San Francisco Peninsula Rail Program

To: Executive Steering Committee
From: Alfonso Rodriguez, DTX Project Director
Date: December 16, 2022
Re: Item 6, Action Item:
Consider Recommending the Addendum to the Transbay Program 2018 Final Supplemental Environmental Impact Report and Revised Mitigation Monitoring and Reporting Program under the California Environmental Quality Act (CEQA), and Modifications to the Downtown Rail Extension Project Analyzed Therein

Addendum to the Transbay Program 2018 Final Supplemental Environmental Impact Report

Figure 2-12. Proposed Realigned Tunnel Stub Box

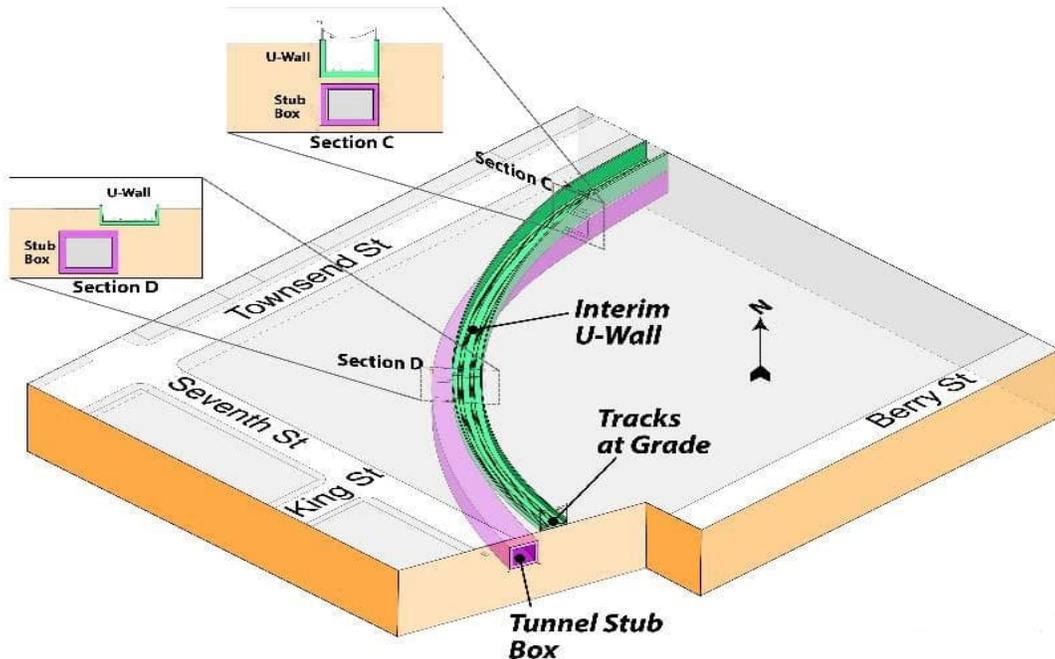
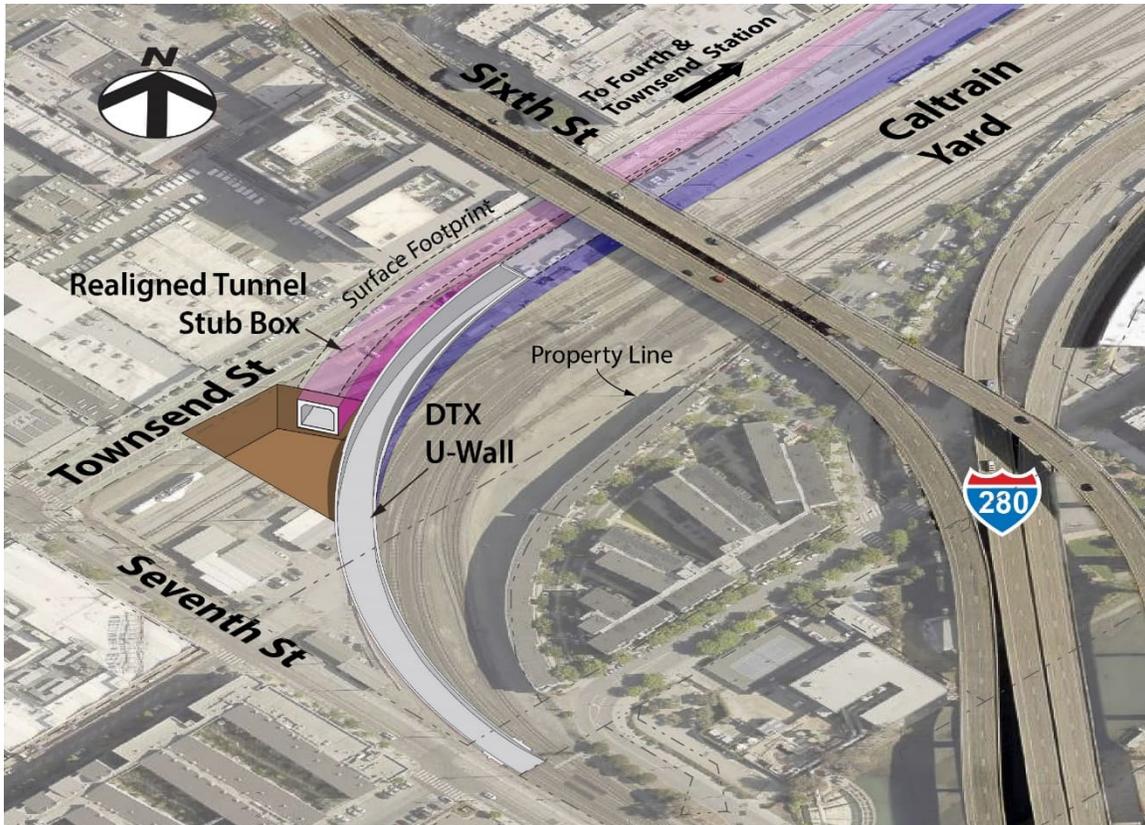
Description and Objective of Proposed Revision. In furthering design of the Fourth and Townsend Street Station and analyzing the operational impacts of the future grade separation tunnel, the tunnel stub box alignment has been refined. The modifications would alter its alignment so that it would be shorter, adjacent to the U-wall rather than underneath it, and partially underneath the Townsend Street right-of-way. The tunnel stub box would be underneath one-half of the width of Townsend Street between Fifth and Sixth Streets and underneath one traffic lane of Townsend Street between Sixth and Seventh Streets, for a total length of approximately 1,000 feet. Only the south side of Townsend Street adjacent to the Caltrain railyard would be affected by the realigned tunnel stub box (stub box shown in pink in Figure 2-12). During the cut-and-cover construction of the tunnel stub box, street-level decking would be laid on Townsend Street, to allow continued vehicular access. No modifications to the U-wall would be required to realign the tunnel stub box.

The proposed realignment of the tunnel stub box to be adjacent to the U-wall would enable both to be used at the same time. The U-wall would be available for trains to move from the railyard into the tunnel, and the tunnel stub box would provide access into the tunnel by a future underground connection for Caltrain and high-speed rail. The rationale for constructing the tunnel stub as part of the Revised Project is the same as presented in the 2018 Final SEIS/EIR; which is to support the future arrival of below-grade Caltrain and HSR service, and to preserve future options regarding grade separations. The proposed alignment would require less excavation than the approved project because of the shallower tunnel stub box. In addition, the proposed alignment of the U-wall and tunnel stub box would allow Caltrain service and movements between the railyard and the tunnel to continue with minimal disruption when the future underground connection is constructed through the western portion of the Caltrain railyard.

Figure 2-14. Proposed Reconfiguration of At-Grade Trackwork at Mission Bay Drive

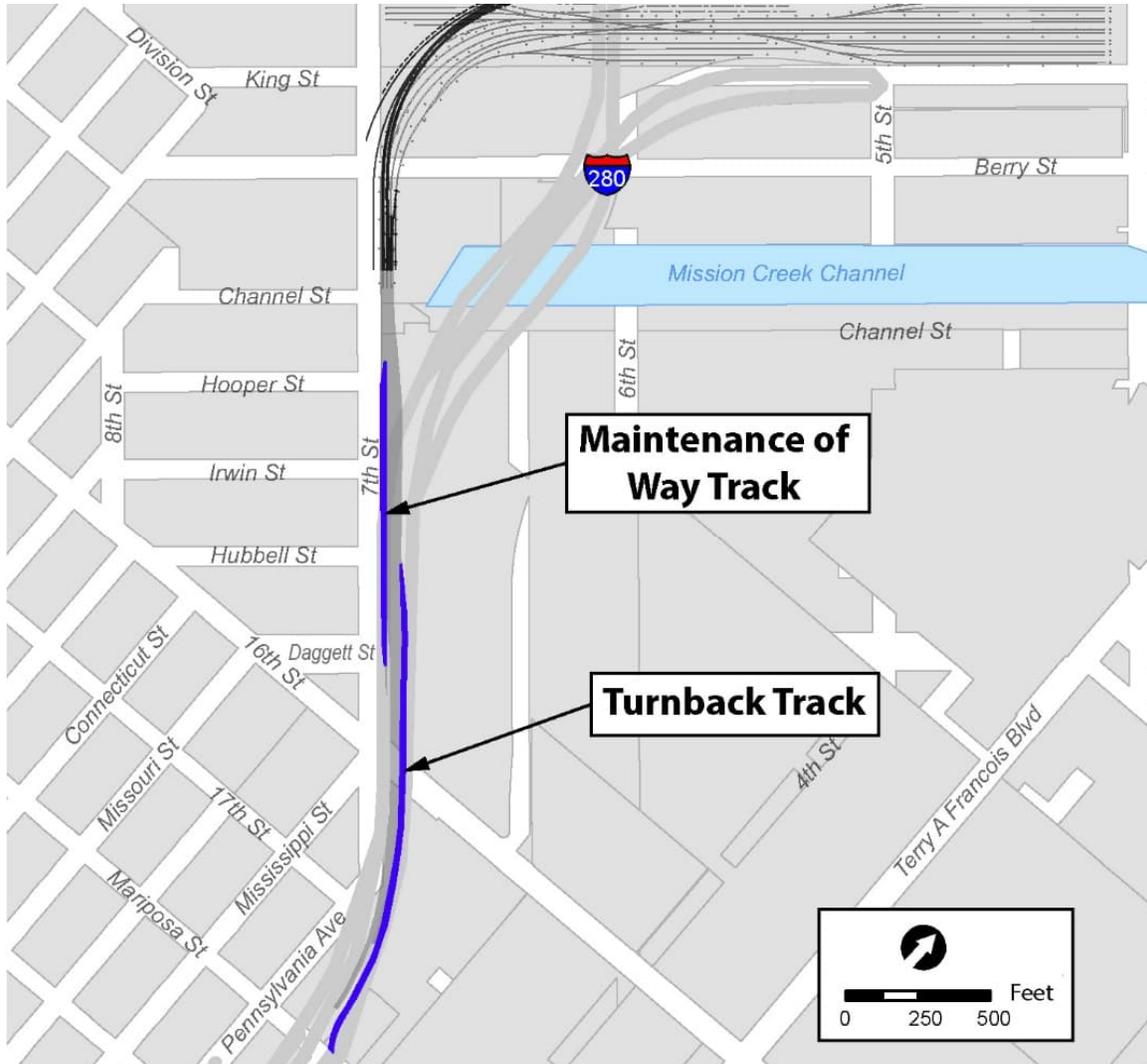
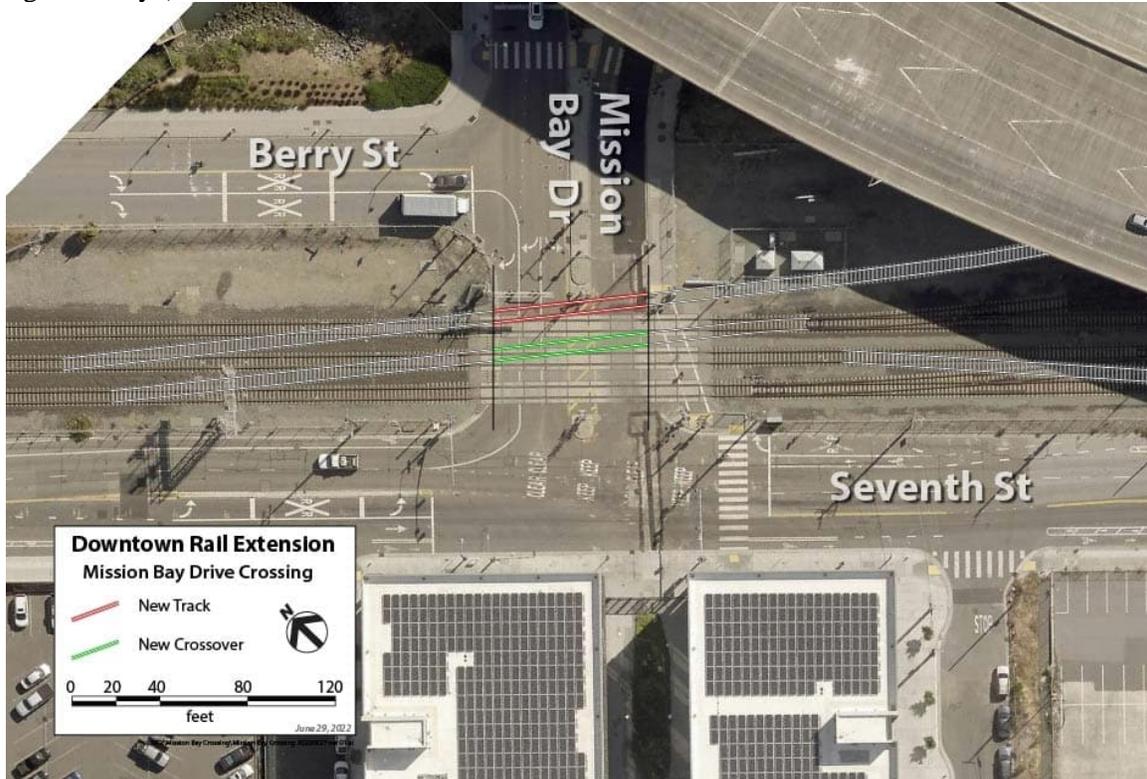
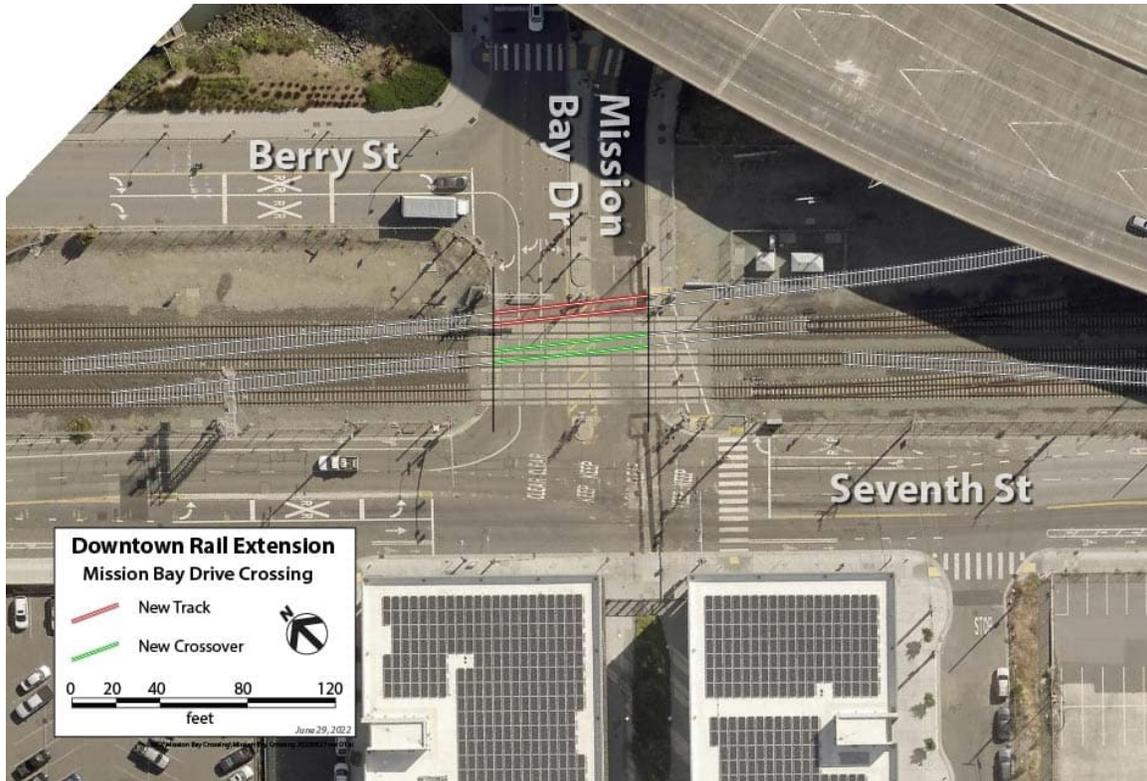
Description and Objective of Proposed Revision. In furthering the design of the at-grade trackwork south of the Caltrain railyard, the TJPA and Caltrain have agreed that relocating the MOW track from the west side of the mainline tracks to the east side, where

it would connect and run parallel to the turnback track, would allow more efficient train movement between the railyard and the Transit Center. This reconfiguration would include an additional track at the existing at-grade crossing of Mission Bay Drive within the Caltrain right-of-way (the red-colored track in

Figure 2-14), resulting in four tracks at this crossing compared to the three existing Caltrain tracks. The additional, fourth track could be used to access either the MOW or turnback track. It would be at a slight angle (further from the other tracks at the south end) and would require moving the east side railroad crossing gate further east along Mission Bay Drive by approximately 9 feet. To facilitate train operations, a new crossover track also would be added between the existing tracks at the Mission Bay Drive crossing (the green-colored track in Figure 2-14). A crossover track is a special trackwork element that allows trains to move from one track to another as directed by the central train control dispatch and the signaling system. The westbound Mission Bay Drive vehicle signal stop line is east of Berry Street; signal timing along Mission Bay Drive at Berry Street is interconnected with the timing at Seventh Street and allows vehicle clearance on the track. The red-colored track (see Figure 2-14) would connect to two existing, MOW tracks on the east side of the Caltrain right-of-way that would be upgraded for use as a MOW or turnback track.

Trains would continue to use the existing tracks at the Mission Bay Drive grade crossing for routine revenue service, while use of the additional MOW/turnback track would occur only during off-peak hours. Caltrain is working to identify the number of off-peak movements for the additional track at Mission Bay Drive based on the Caltrain Business Plan.

Figure 2-15. Proposed Reconfiguration of At-Grade Trackwork South of the Caltrain Railyard

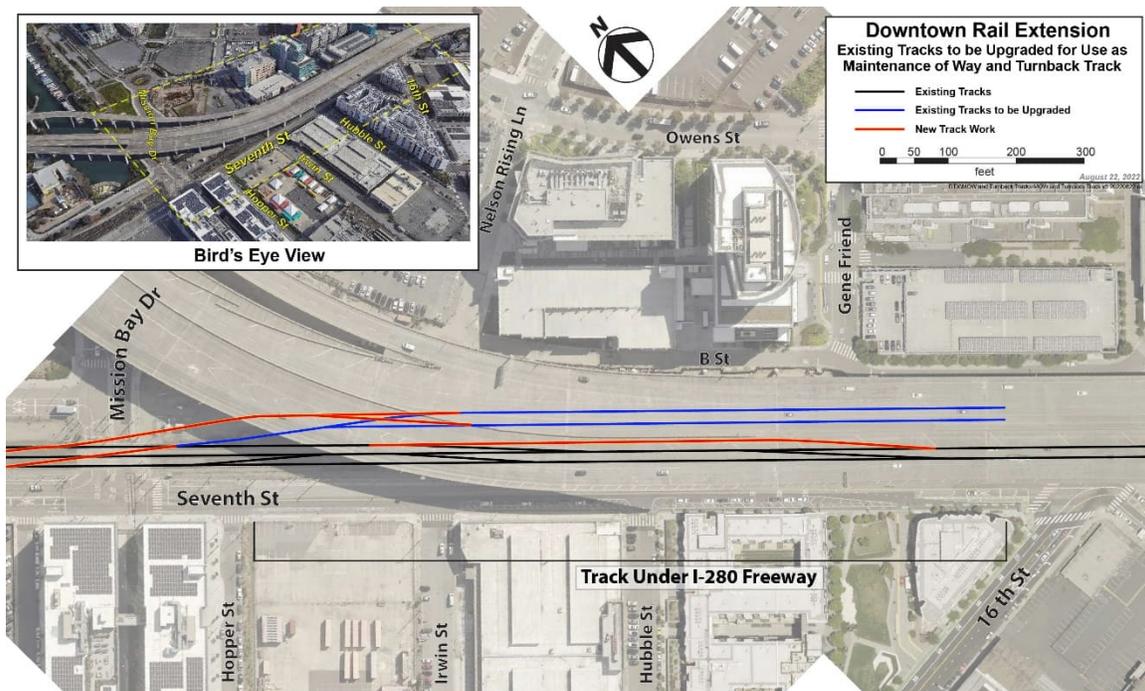
In addition to the changes to the trackwork at Mission Bay Drive, another new track within the Caltrain right-of-way between existing tracks, from approximately just north of Irwin Street to just north of 16th Street, would be constructed to provide operational flexibility. This project modification was developed by TJPA in collaboration with Caltrain, and would, in conjunction with the additional track at Mission Bay Drive, eliminate the need for the turnback track to extend across 16th Street and continue to Mariposa Street. Figure 2-15 shows this new track, as well as the new track across Mission Bay Drive described above.
